### Office Action Summary

10/784,385

Claims 1-5 are rejected under 35 U.S.C. 103(a) as being unpatentable over US patent 4257268, Pepicelli et al in view of US patent 6117394, Smith.

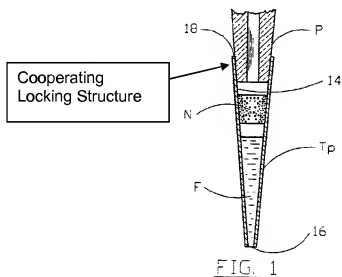
In regards to claim 1, Pepicelli et al disclose a mounting fixture for connecting pipettes of various sizes to the air channel of a pipettor, the fixture comprising a tubular nose (240) having a proximate end secured to the pipettor and an open distal end; and a resilient retainer (242) lining the interior of the nose, the retainer having an axial passageway communicating at its entry and exit openings respectively with the open distal end of the nose and with the air channel of the pipettor, the passageway being tapered from a maximum diameter at the entry opening to a minimum diameter at the exit opening, the entry opening being sized to axially receive the largest of the pipettes and the sleeve being internally configured to resiliently grip differently sized pipettes inserted therein at different locations along the length thereof. Pepicelli does not disclose a stabilizing member at the open distal end of the nose with a cooperating locking structure. Smith teaches a stabilizing member (Tp) at the open distal end of the nose (P) to limit the possibility of cross contamination between samples (col. 1, lines 8-13). As Smith relates to disposable tips for pipette devices, it would have been obvious

to one having ordinary skill in the art at the time the invention was made to provide a stabilizing member at the open distal end of the nose with a cooperating locking structure to limit the possibility of cross contamination between samples, as taught by Smith.

Applicant's arguments filed 6/6/2008 have been fully considered but they are not persuasive. Applicant argues that the prior art fails to disclose a cooperating locking structure. The Examiner disagrees. In Figure 1 above, Smith clearly illustrates a cooperating locking structure.
